TO: Mayor J. Clark Boddie, City of Palmetto
ATTN TO: Cindy Hanson, City Clerk, City of Palmetto
FROM: Mike Alexander, Director, ARC Center for Livable Communities
RE: Development of Regional Impact (DRI) Review

Name of Proposal: Core5 at Palmetto Logistics Center

Description: A DRI review of a proposal to construct approximately 1,064,850 SF of warehouse distribution facility space in two buildings on a 141 acre site on Palmetto Logistics Parkway in the City of Palmetto. The site is currently mostly wooded with several floodplain and stream areas.

BUILDING 4 AND 3
DRI PLAN

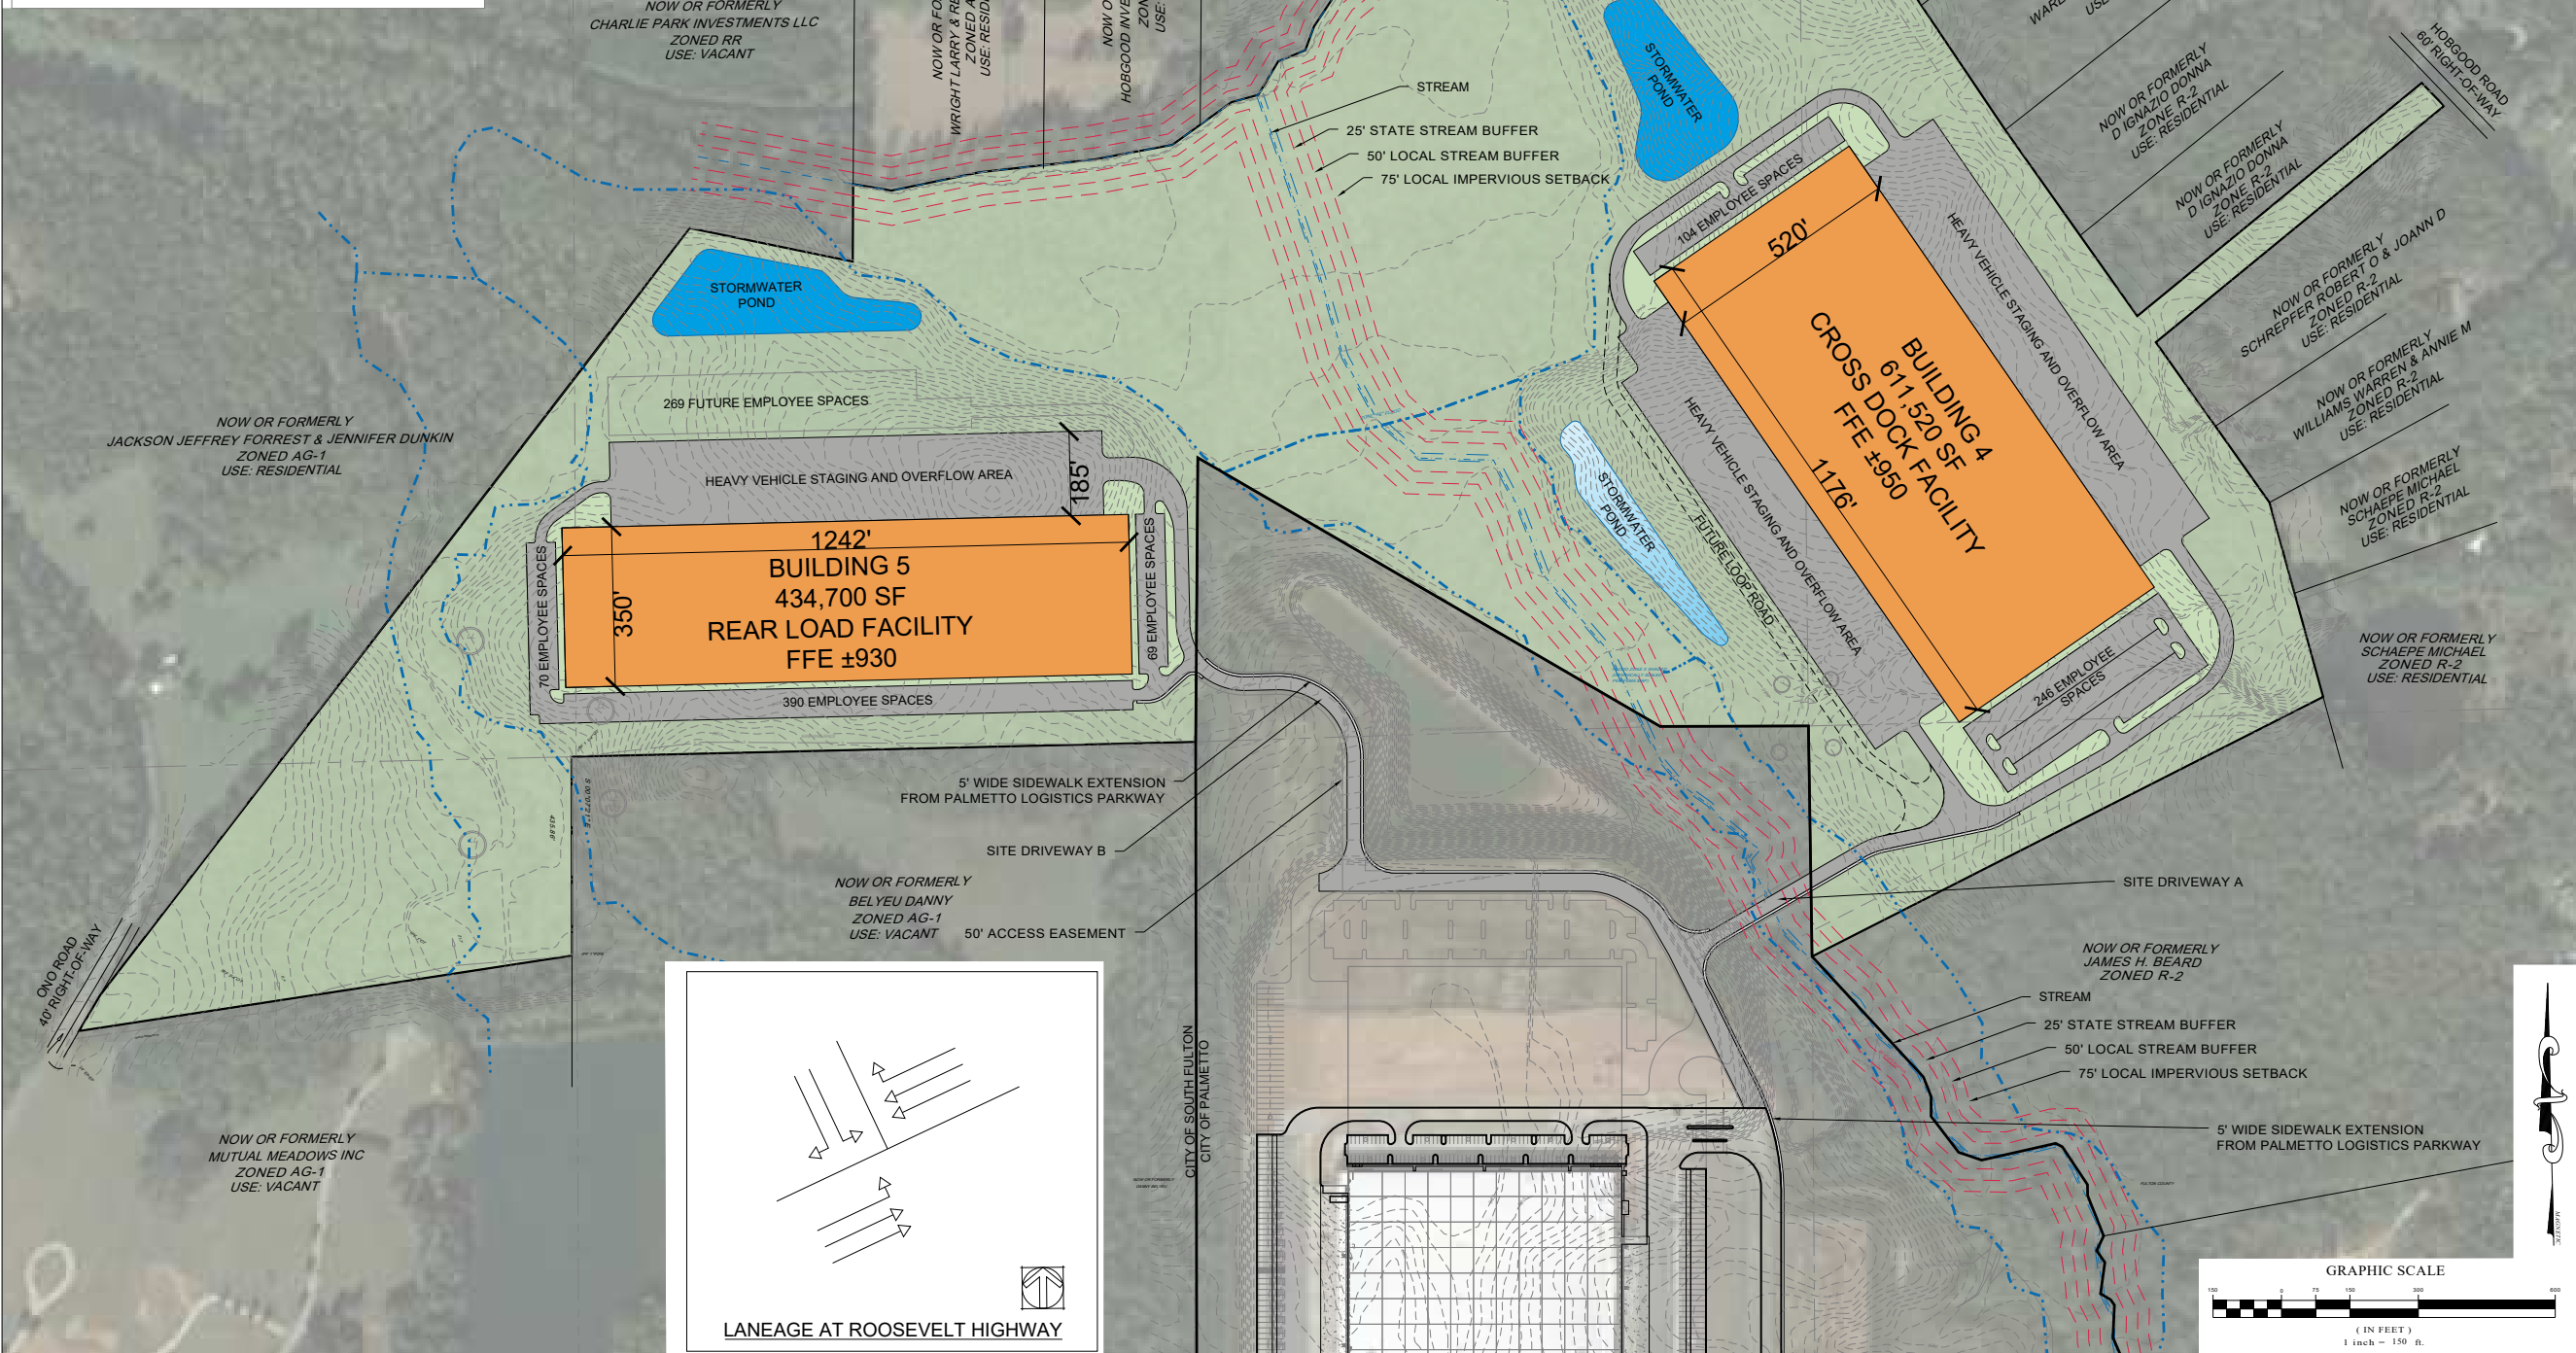
A total of 758 parking spaces and 181 trailer spaces are proposed but no EV charging spaces are included; provision of some EV charging spaces would be in keeping with regional EV infrastructure policies.

Care should be taken to ensure that the constructed development provides an interconnected, functional, clearly marked and comfortable pedestrian experience on all driveways, paths, entrances, and parking areas. To the maximum extent possible, new driveways and intersection corners where pedestrians will cross should be constructed with minimal curb radii to reduce speeds of turning vehicles and decrease crossing distances for pedestrians.

Both the project site plan and the USGS coverage for the project area show Bear Creek along the northern boundary of the project property, with an unnamed tributary to Bear Creek running roughly southeast to northwest through the project property. The submitted project site plan shows the 50-foot undisturbed buffer and additional 25-foot impervious surface setback required under the City of Palmetto Stream Buffer Ordinance, as well as the State 25-foot Erosion and Sedimentation Buffer on both streams. The only intrusion into the buffers shown on the plans is a driveway crossing the unnamed tributary, which is allowed under the Palmetto Stream Buffer Ordinance. Any unmapped streams on the property may also be subject to the Palmetto Stream Buffer Ordinance. Any other waters of the State on the property are also subject to the 25-foot state Erosion and Sedimentation Act buffers.

Approximately 64%, or 90 acres, of the 141-acre site is proposed as open space and there appear to be no intrusions into stream buffers. Retention of additional natural wooded areas around the existing streams would be in keeping with regional policies regarding water resource protection, carbon sequestration and heat island mitigation. The proposed open space is quite large at 90 acres, but this space is not integrated into any larger managed conservation or park area. Developing a strategy to ensure the ongoing protection and appropriate utilization of this area for conservation and passive park purposed would be very supportive of regional environmental policies as well as the core Atlanta Region's Plan Rural Area recommendation.

The project can further support The Atlanta Region's Plan by incorporating other aspects of regional environmental policy, including green infrastructure and/or low-impact design, e.g., pervious pavers, rain gardens, vegetated swales, etc., in the large surface parking areas proposed, site driveways, and as part of any improvements to site frontages.
